1 **QUESTION:**

1  
2 **Revised Response based on YUB Order 2023-25, Appendix B**

14 **Revised Response for “a” based on YUB Order 2023-25, Appendix B**

FARO DIESEL & SUBSTATION  
 SITE PLAN  
 LOT 413, FARO - YUKON

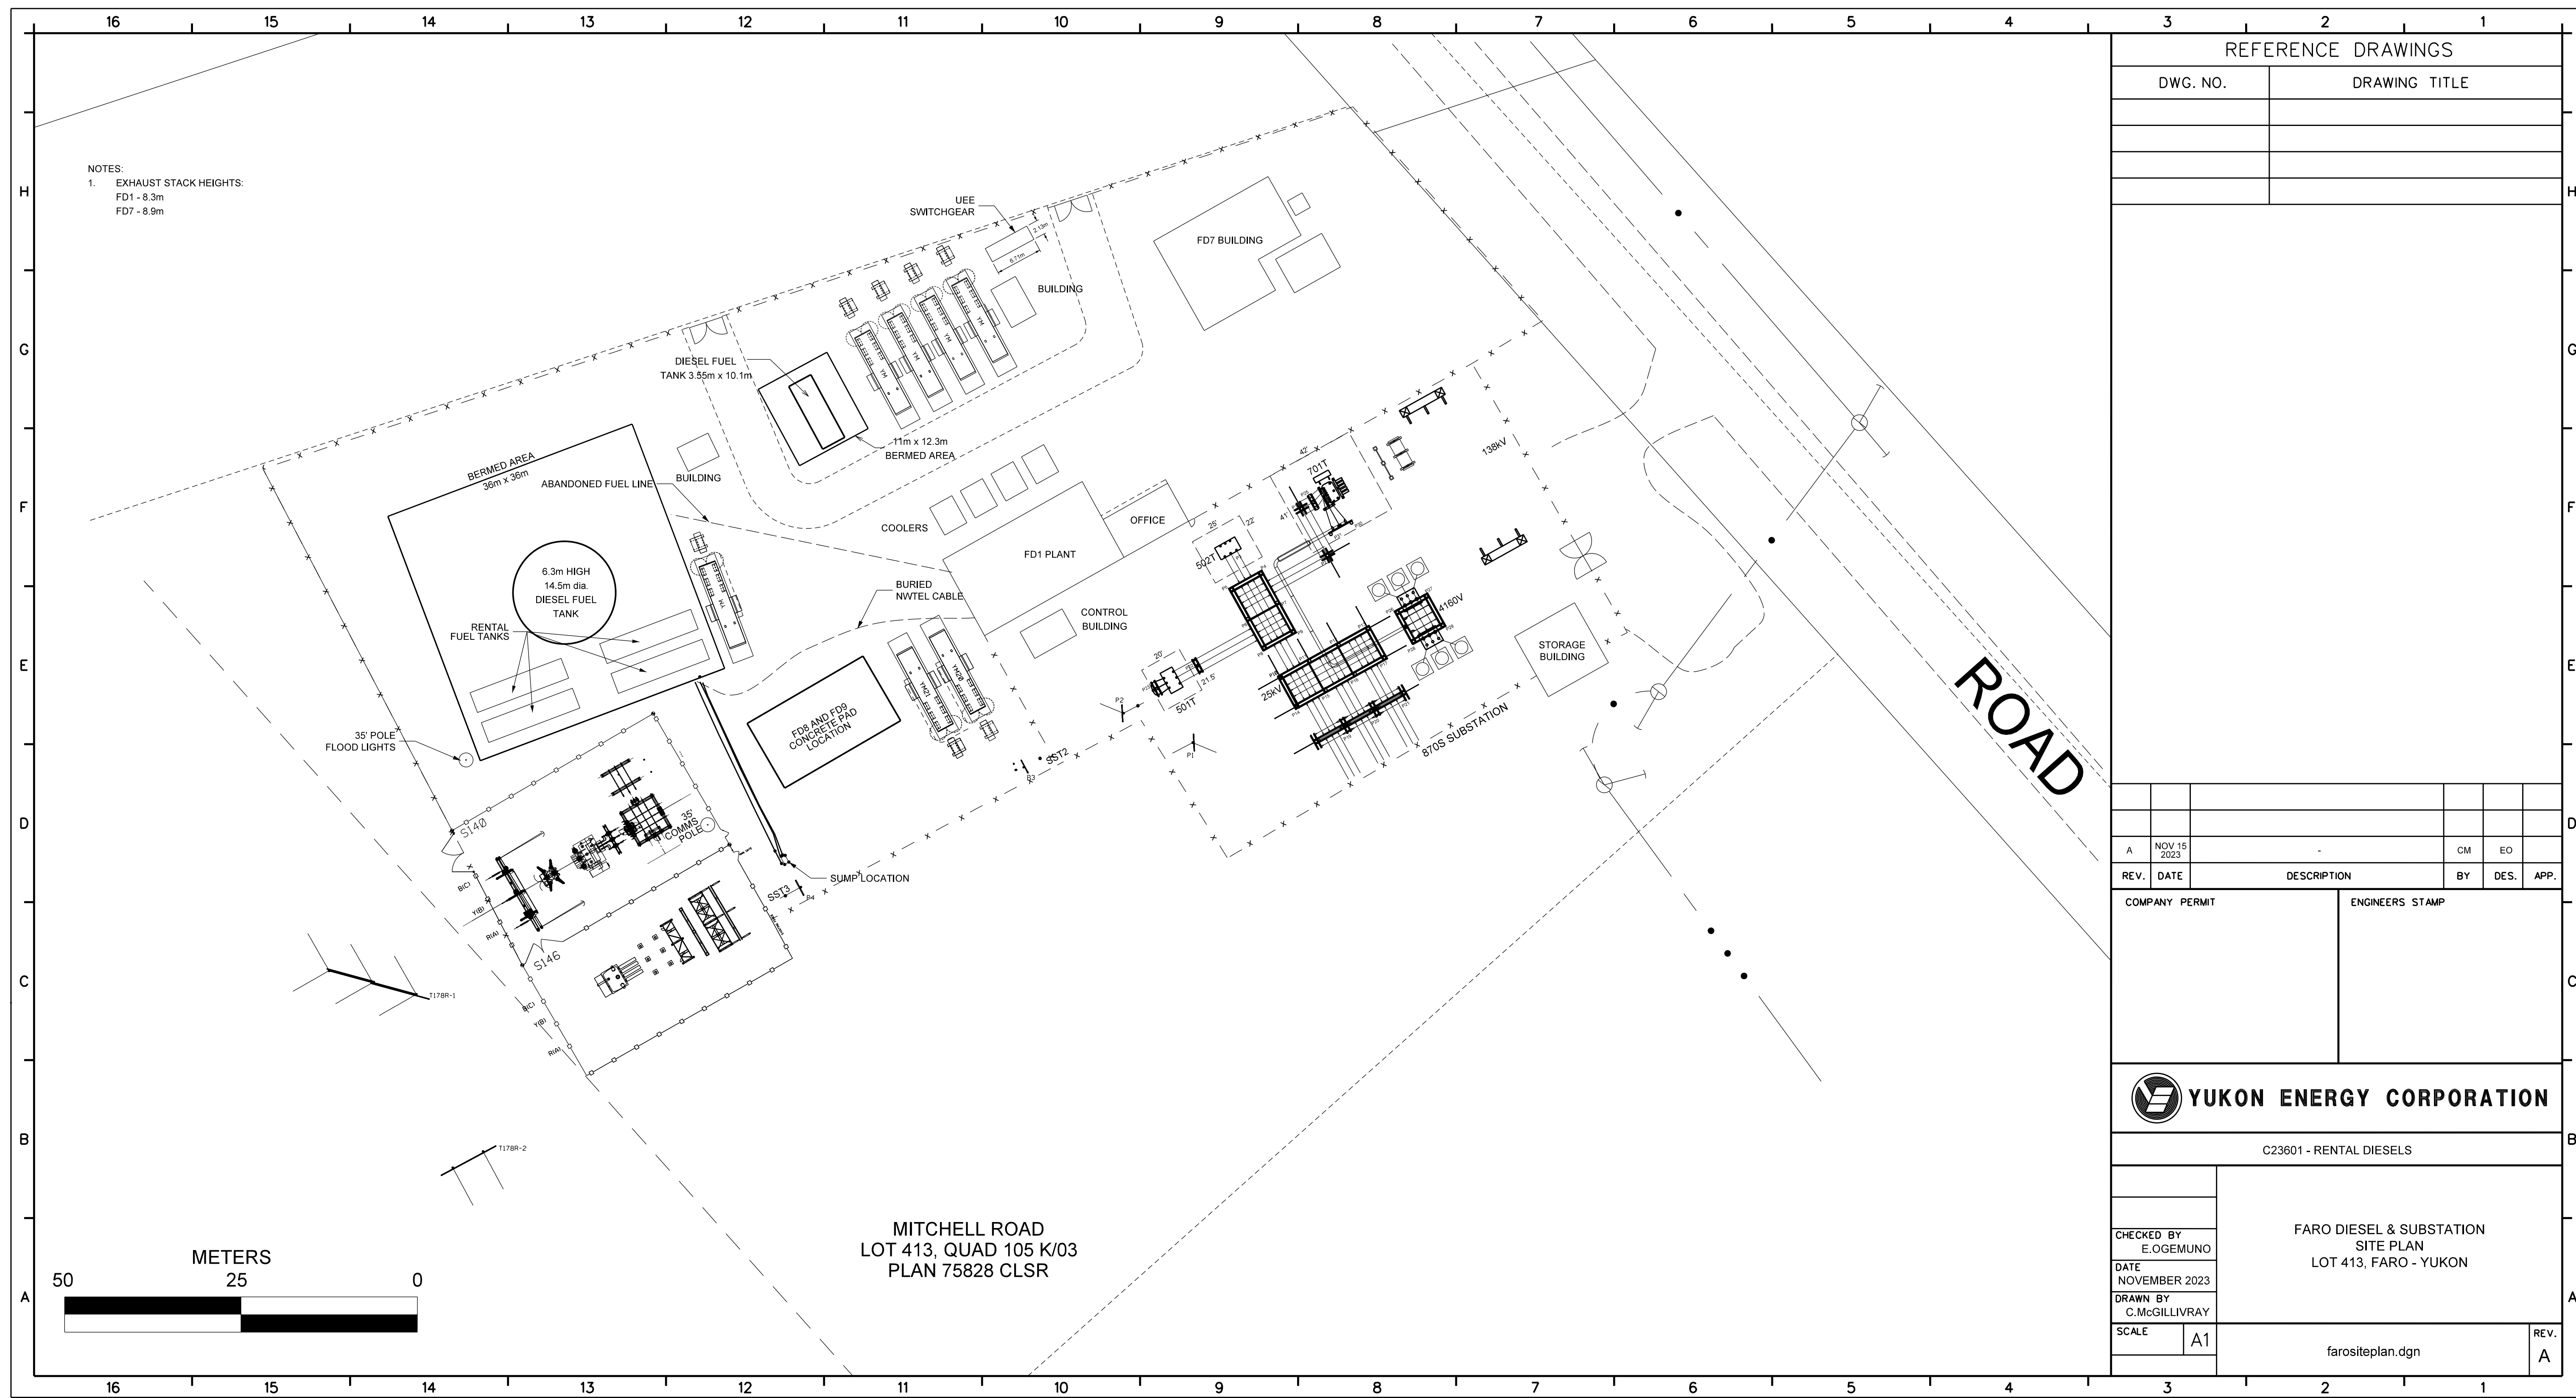
35 Please see NY-YEC-1-14(a) REVISED Attachment 2 for a copy of the following Faro site

- 1           1. A higher resolution copy of the site layout originally filed, as directed by Appendix  
2           B to Order 2023-25; and  
3  
4           2. A site layout showing the location of all generators, including seven diesel rental  
5           units (four on top, one next to the fuel tank, and two next to the location for the two  
6           new engines FD8 and FD9), requested by Mr. Yee's January 5, 2024  
7           correspondence to the Board following YEC's January 4, 2024 filings on NY-YEC-  
8           1-14 REVISED.

NOTES:  
 1. EXHAUST STACK HEIGHTS:  
 FD1 - 8.3m  
 FD7 - 8.9m

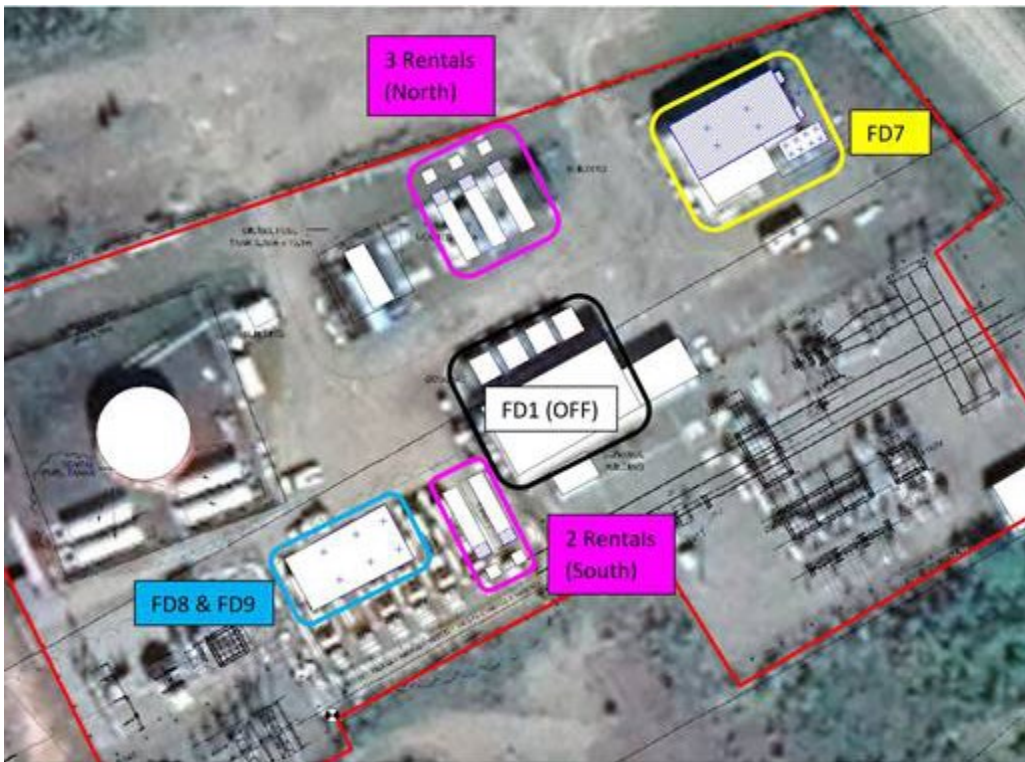
Which rental generators are being moved?

How far from their current location? A figure would be ideal. **RESPONSE: See above and attached.**

**RESPONSE:** Due to noise complaints we are planning to relocate 3 of the remaining 5 rental units to a location approximately 45 metres northwest of their current location. This will allow the existing FD1 building to provide some sound attenuation during their operation. We are evaluating the feasibility of additional sound attenuation for the remaining rental units as part of our planning, but don't have an engineering assessment or cost estimate completed yet. See draft site sketch below for planned locations of units.
